Project: WEBSTER UNIVERSITY
Customer: PARIC
Owner: WEBSTER UNIVERSITY
Location: WEBSTER GROVES, MO.
Dwn: SAM Date: 09-26-16 Ckd: BD Date: 9-29-16
Job No. A16013M DWG#: 7

SUBMITTAL IDENTIFICATION SHEET

WEBSTER UNIVERSITY ISB
PROJECT NAME

057500-001
CONTRACTOR / CM SUBMITTAL NO.

2 HANDRAILS 7A

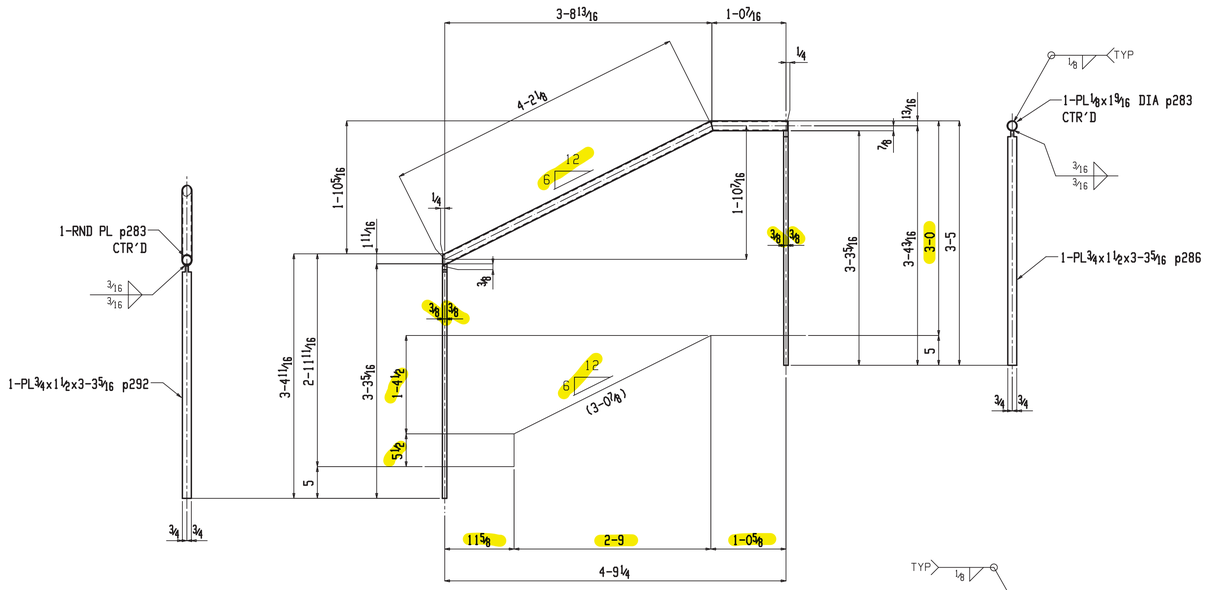
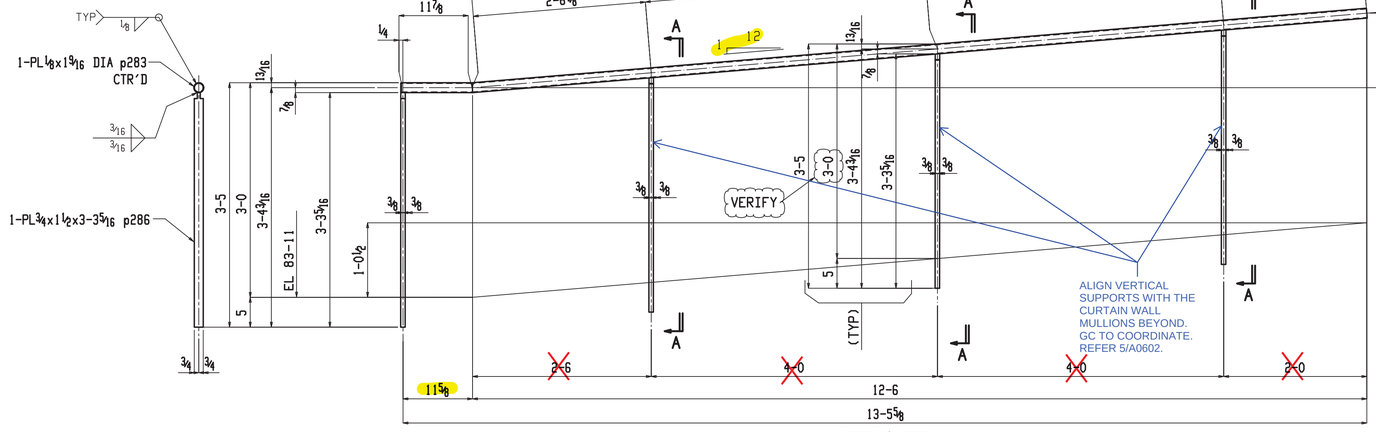
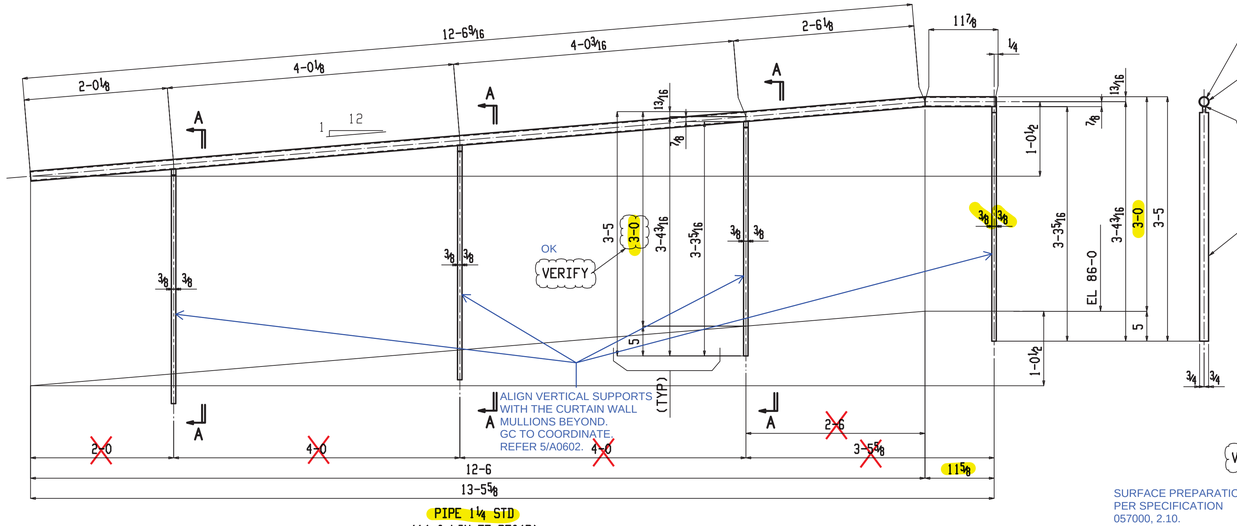
GC TO COORDINATE HEIGHT WITH ROOF HATCH.

SUBMIT SHOP DRAWINGS & PRODUCT DATA. FIRST STEP OF THIS STAIR TO BE ON THE RIGHT SIDE ALONG THE WALL.

ALIGN VERTICAL SUPPORTS WITH THE CURTAIN WALL MULLIONS BEYOND. GC TO COORDINATE. REFER 5/A0602.

ALIGN VERTICAL SUPPORTS WITH THE CURTAIN WALL MULLIONS BEYOND. GC TO COORDINATE. REFER 5/A0602.

HANDRAIL DETAIL PER RFI-280 RESPONSE
